**Proposed Text for Section 5.3**  
**Based on responses to Draft D1 Letter Ballot processed**  
**at May, 1995 Meeting of IEEE P802.11**

**Abstract:** This paper presents the changes to section 5.3 in the Draft Standard P802.11/D1 as a result of the Response to Draft D1 Letter Ballot processed at the May, 1995 meeting of IEEE P802.11 as shown in the companion Documents P802.11-95/100. All Letter Ballot comments marked as pertaining to section 5.3 were processed at the May, 1995 meeting.

**Action:** Adopt the changes in this paper to replace the relevant portions of P802.11/D1.1.

Figure 5-15: CFP / CP Alternation PCF Superframe Construction

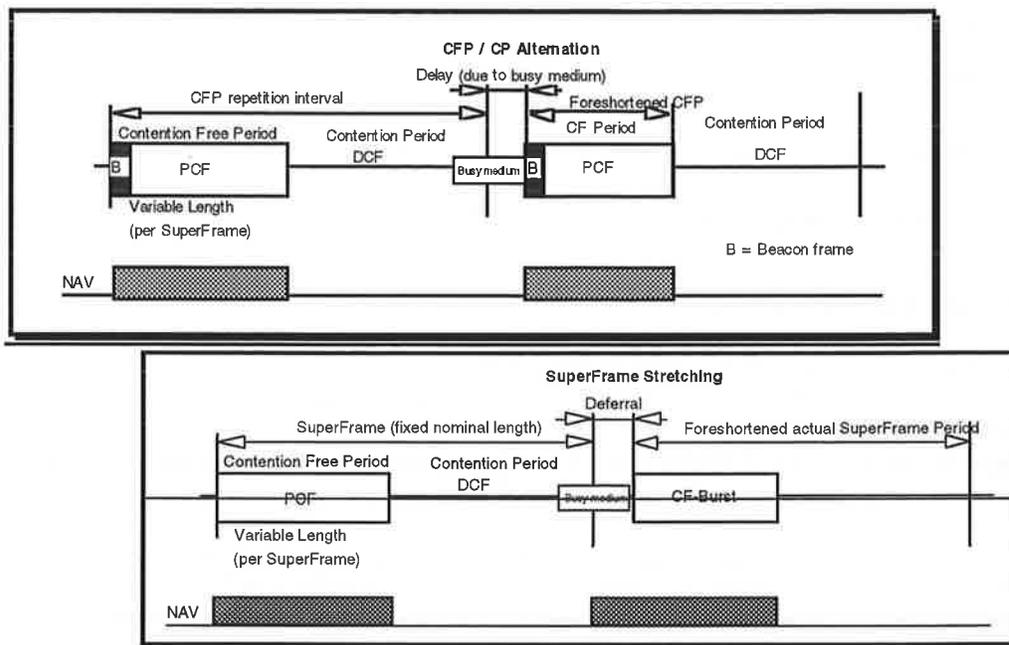
The PCF controls frame transfers during ~~uses~~ a Contention Free Period Superframe (CFPSF) structure. The CFP alternates with a Contention Period (CP), when the DCF controls frame transfers, as shown in Figure 5-15. Each CFP begins with a Beacon frame that contains a DTIM Element (hereafter referred to as a “DTIM”). The CFPs occur at a defined repetition rate, which is synchronized with the beacon interval as specified below. The Superframe is constructed of two major components; a Contention Free (CF) period and a Contention Period. Within a given SF period, the PCF shall be active in the Contention Free Period, while the DCF shall be active in the Contention Period.

**Figure 5-17: Example of Delayed Beacon and Foreshortened CFP**

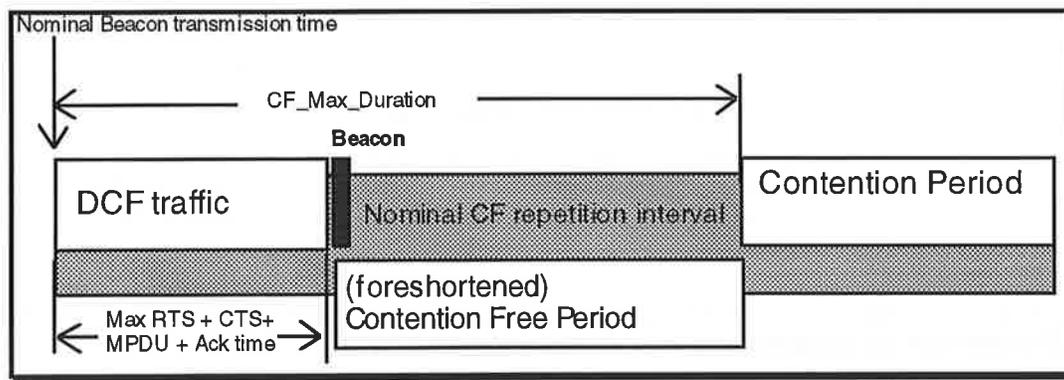
The PC may terminate any CFP at or before the CFP Max Duration, based on available traffic and size of the polling list. Because the transmission of any beacon may be delayed due to a medium busy condition at the nominal beacon transmission time, a CFP may be foreshortened by the amount of the delay. In the case of a busy medium due to DCF traffic, the upper bound on this delay is the maximum RTS + CTS + max MPDU + Ack duration. In cases where the beacon transmission is delayed, the CFP Dur Remaining value in the beacon at the beginning of the CFP shall specify a time that causes the CFP to end no later than the nominal beacon transmission time plus the value of a CFP Max Duration. This is illustrated in figure 5-17. The length of the Contention Free Period may be variable in length on a per-SF basis.

Figure 5-186: Example of PCF Frame Transfer Protocol Operation

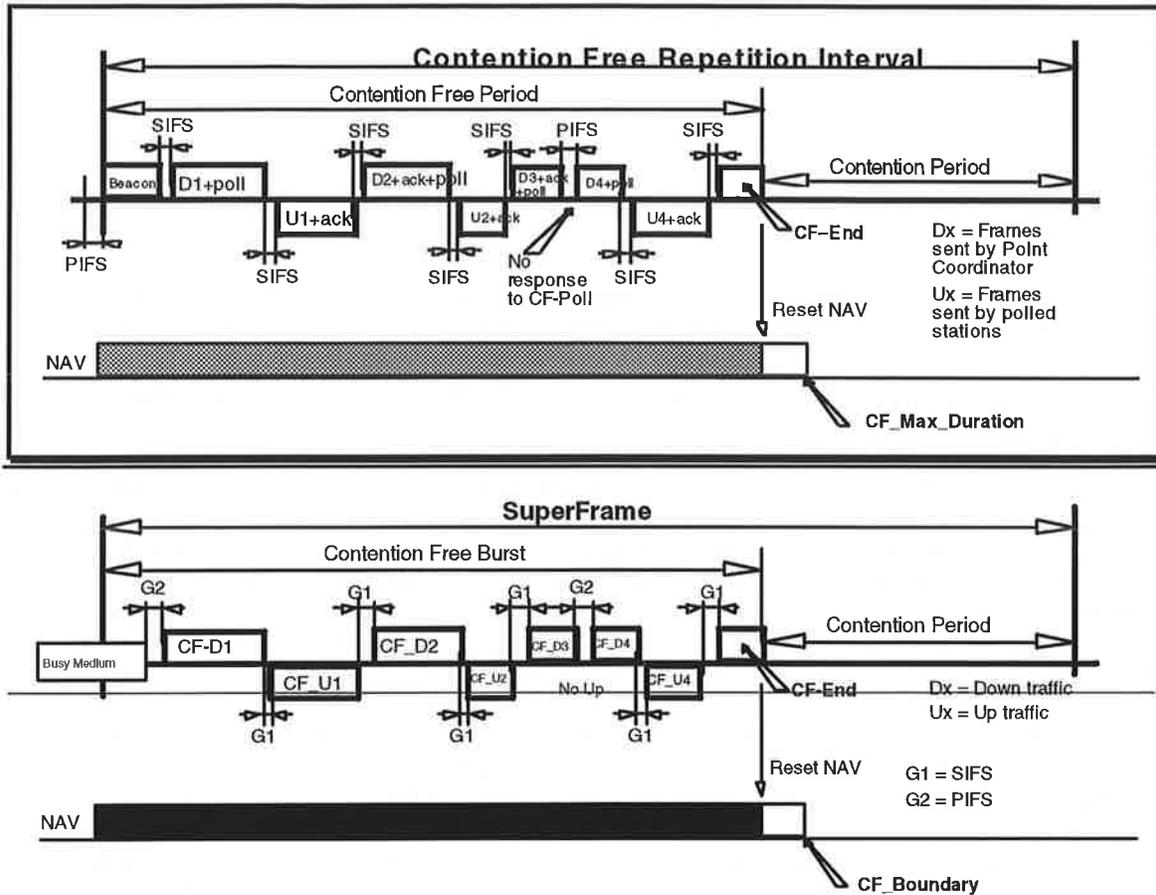
~~Frame transfer under the PCF typically consists of alternating between frames sent from the AP/PC and frames sent to the AP/PC. During the CFP, the ordering of these transmissions, and the station allowed to transmit frames to the PC at any given point in time, is controlled by the PC. Figure 5-18 depicts a frame transfer during a typical CFP. The rules under which this frame transfer takes place are detailed in the following paragraphs.~~

Figure 5-20: DynamicExample Polling List Update Technique

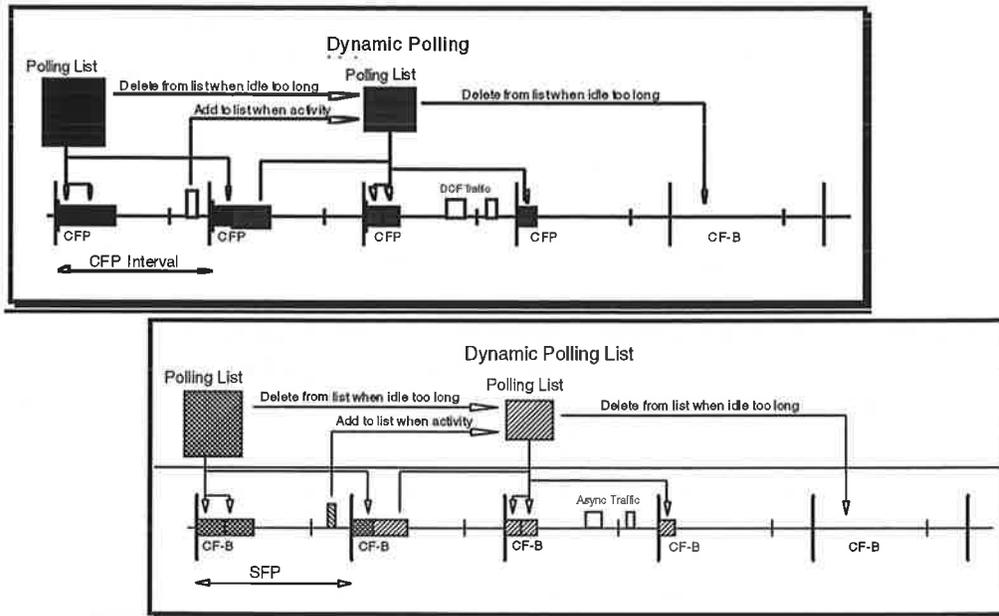
CF-Aware stations that are not on the polling list due to a static request during Association, and are not excluded from the polling list due to a static request during Association, may be dynamically placed on the polling list by the PC to handle bursts of frame transfer activity by that station. The manner in which the PCF updates the polling list is outside the scope of this standard. One possible mechanism, provided as an example, is for the PCF to monitor CF-aware station activity during both the Contention Free period and the contention period. When a CF-aware station placed on the polling list dynamically has not transmitted a Data frame in response to responded to the predefined number of successive CF-Polls indicated in a Poll Inactivity, then the PCF may delete that station from the polling list. When a CF-aware station not on the polling list, but not excluded from the polling list, has transmitted any predefined number of Data frames during the previous contention periods, then the PCF may add that station to the polling list. -This is illustrated in Figure 5-20.
